Document Update Notification

DOCUMENT NO: OP-1903.010

TITLE: EMERGENCY ACTION LEVEL
CLASSIFICATION

CHANGE NO: 037-01-0

ATTACHMENT 5
UNIT 1

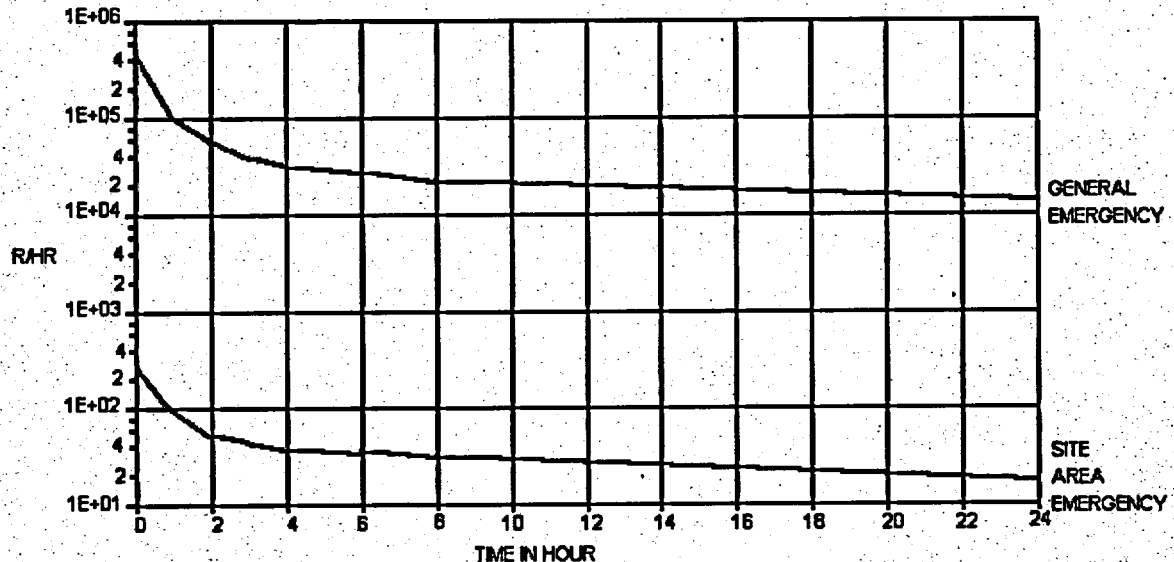
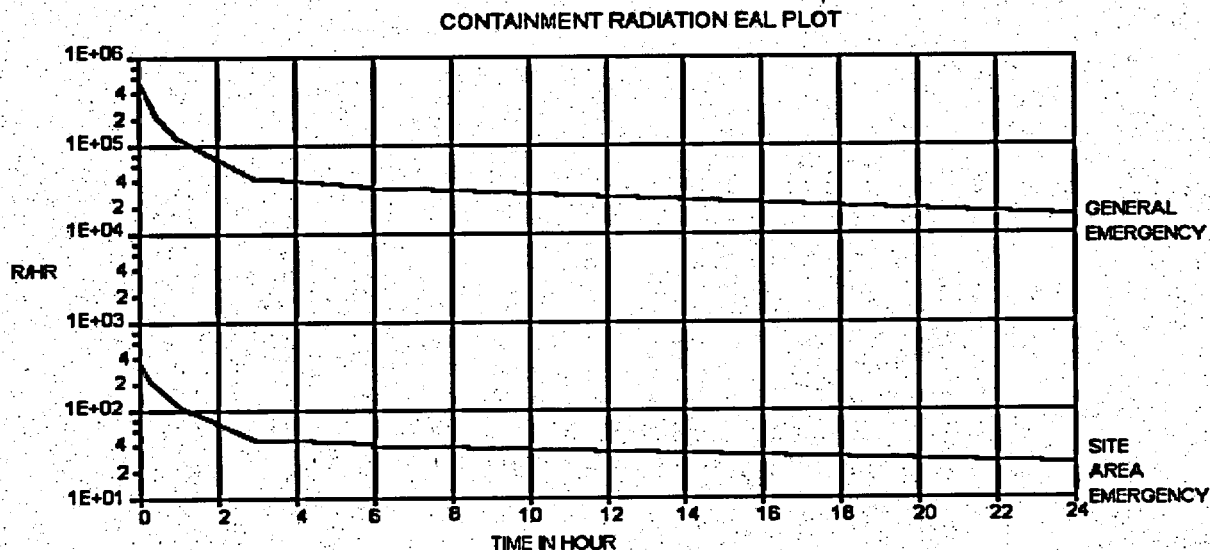
Pages 32-34	Added "(other than for normal post trip response)" to "MSSVs maintaining OTSG pressure"		
Pages 47, 48	Modified criteria to take credit for a successful Diverse Scram System trip when RPS fails to trip the unit.		
Pages 127, 128	Deleted note on Attachments 5 & 6 which referenced Attachments 7 & 8 of 1903.011. Attachments 7 & 8 of 1903.011 have been deleted.		
FORM TITLE: DESCRIPTION OF CHANGE		FORM NO. 1000.006C	CHANGE NO. 050-00-0
